INTERCHANGE NO. 2 SIGN & GUARDRAIL DETAIL SHEET

SURVEYED BY N/A DATE N/A
DRAWN BY T.J.B. DATE 8/98
SQUAD LEADER T.P.K.
DESIGN FILE NO. /pave/96b154/pb154.dgn
IPARM FILE pb154d04.i DATE PLOTTED N/A
PROJ. NAME FAIR HAVEN - RUTLAND
PROJ. NO. NH 9727(I)S
SHEET 32 OF I19 SHEETS

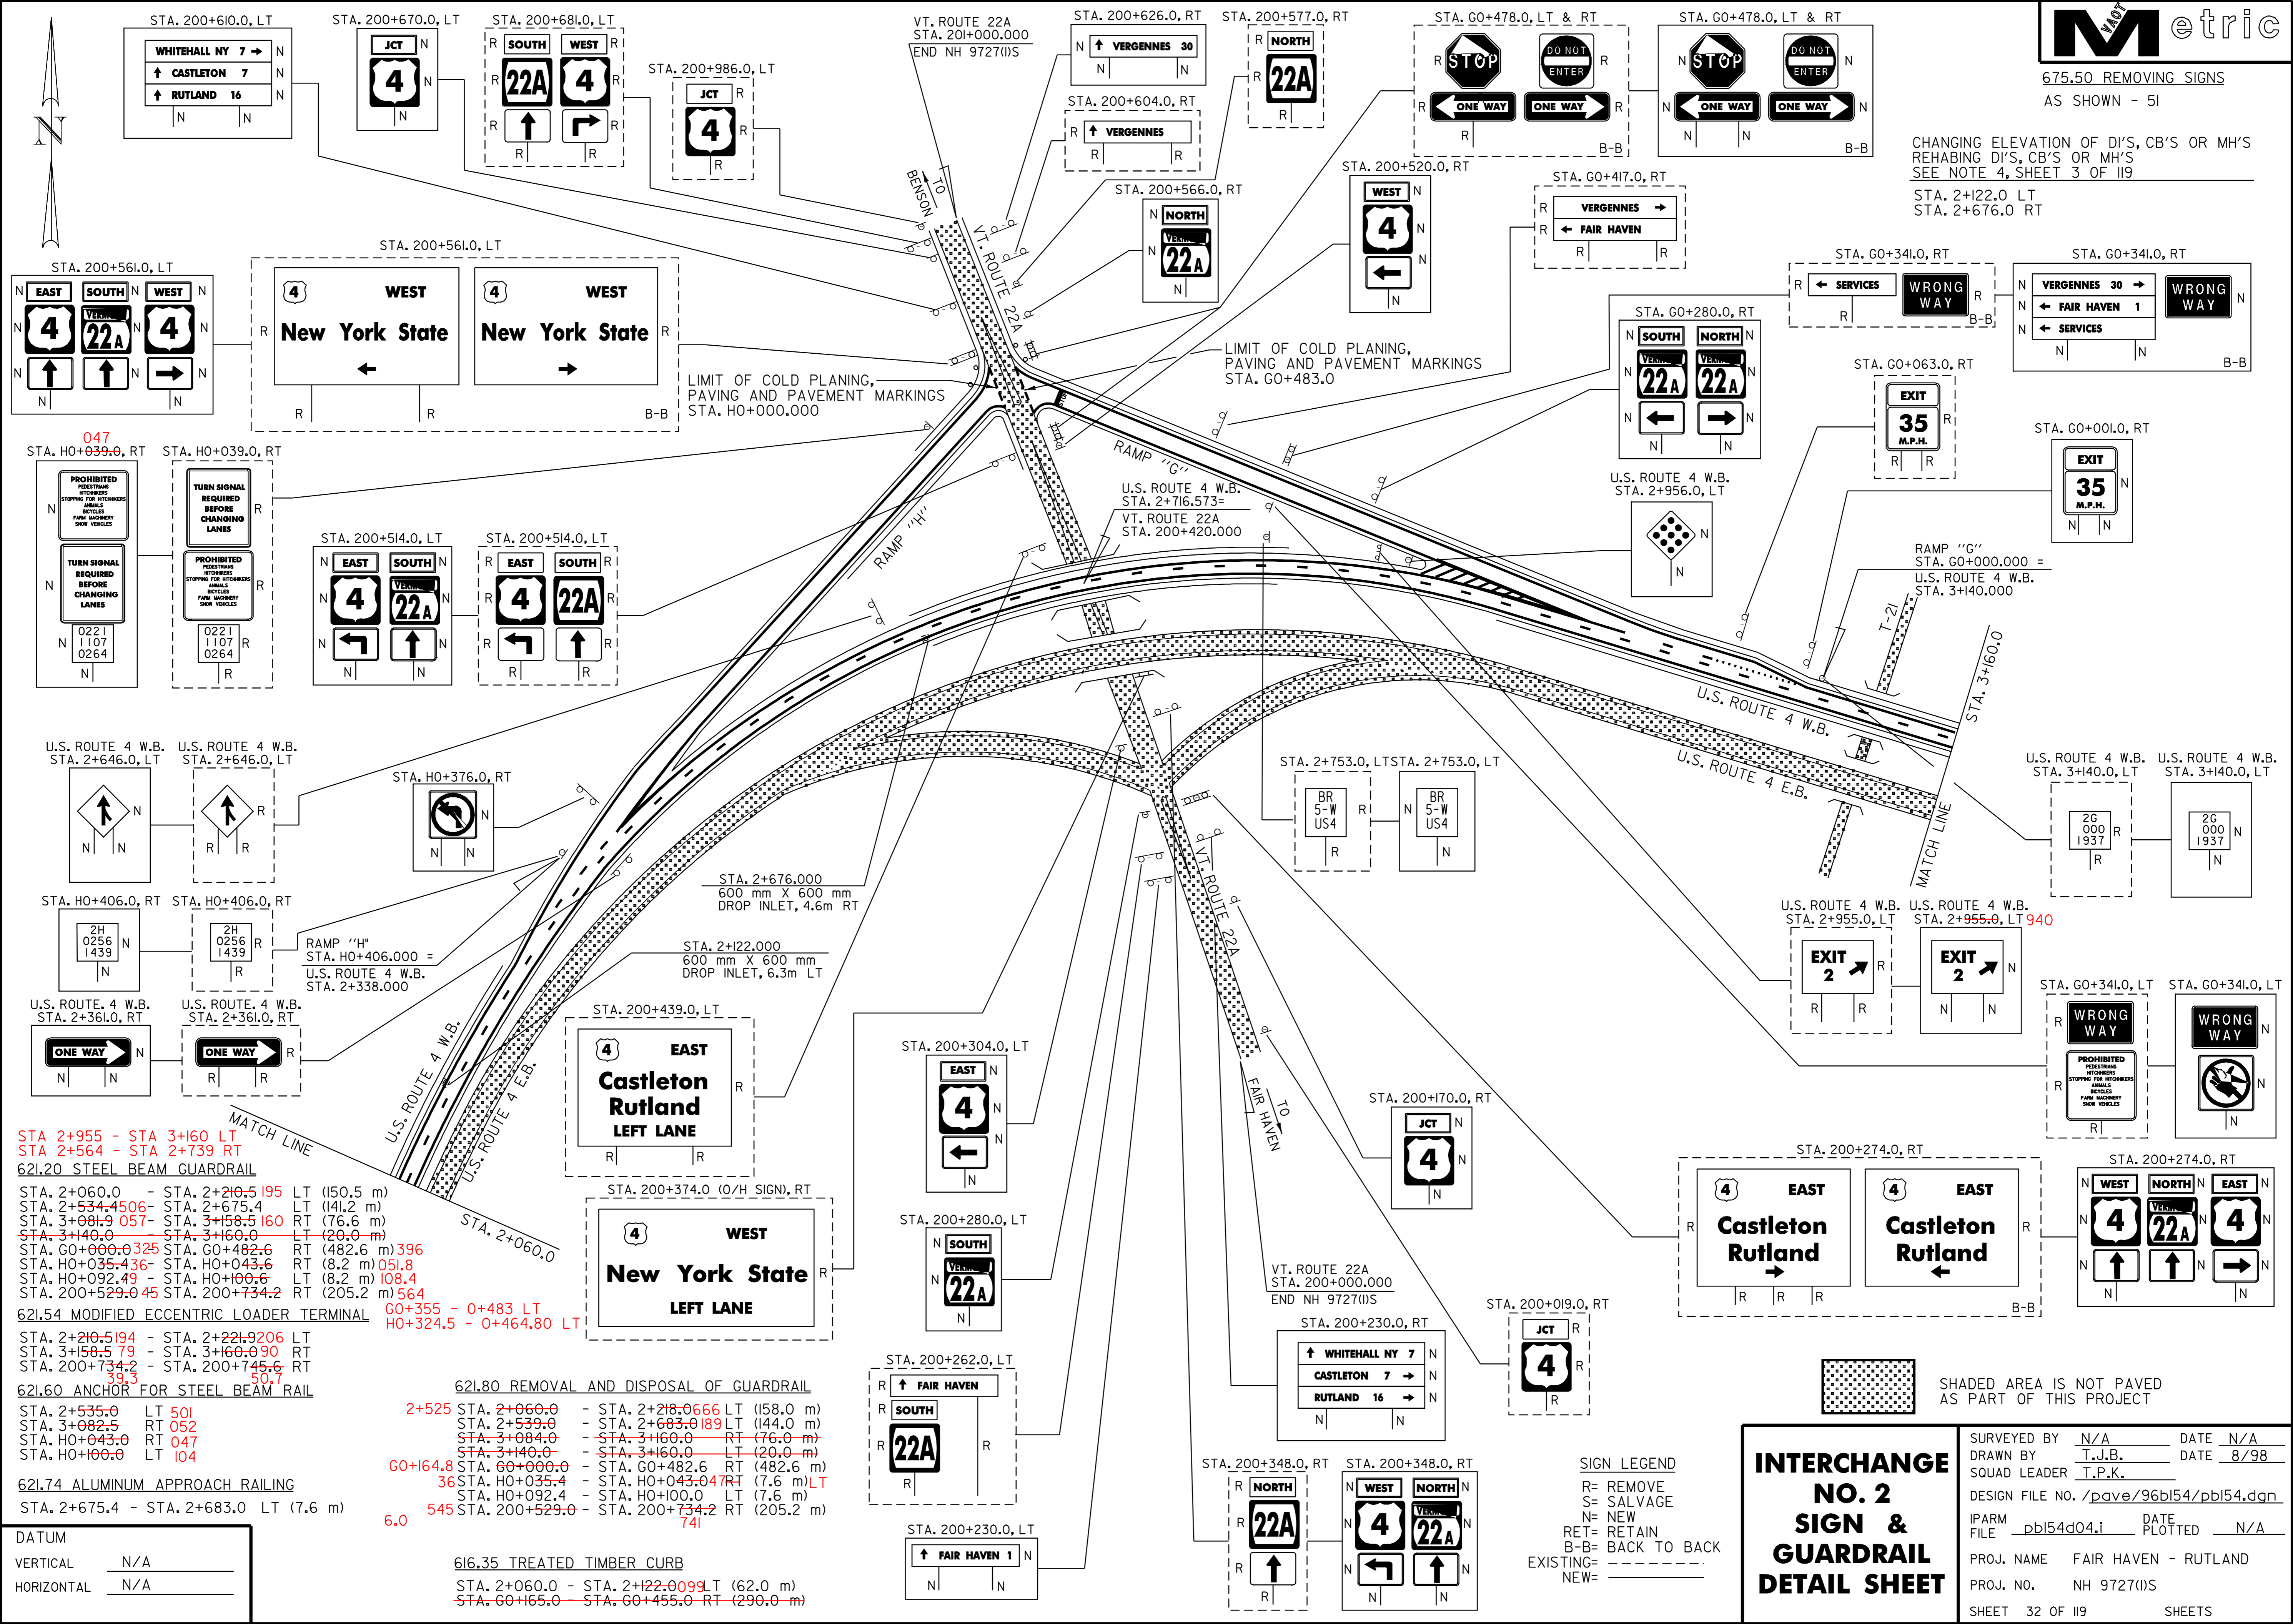
STA. 2+060.0	-	STA. 2+210.5	195	LT	(150.5 m)	
STA. 2+534.4	506	-	STA. 2+675.4	LT	(141.2 m)	
STA. 3+081.9	057	-	STA. 3+158.5	160	RT	(76.6 m)
STA. 3+140.0	-	STA. 3+160.0	LT	(20.0 m)		
STA. GO+000.0	325	STA. GO+482.6	RT	(482.6 m)	396	
STA. HO+035.4	436	-	STA. HO+043.6	RT	(8.2 m)	051.8
STA. HO+092.4	9	-	STA. HO+100.6	LT	(8.2 m)	108.4
STA. 200+529.0	45	STA. 200+734.2	RT	(205.2 m)	564

2+525	STA. 2+060.0	-	STA. 2+218.0	0666	LT	(158.0 m)
	STA. 2+539.0	-	STA. 2+683.0	089	LT	(144.0 m)
	STA. 3+084.0	-	STA. 3+160.0	RT	(76.0 m)	
	STA. 3+140.0	-	STA. 3+160.0	LT	(20.0 m)	
GO+164.8	STA. GO+000.0	-	STA. GO+482.6	RT	(482.6 m)	
36	STA. HO+035.4	-	STA. HO+043.0	RT	(7.6 m)	LT
	STA. HO+092.4	-	STA. HO+100.0	LT	(7.6 m)	
6.0	545	STA. 200+529.0	-	STA. 200+734.2	RT	(205.2 m)
						741
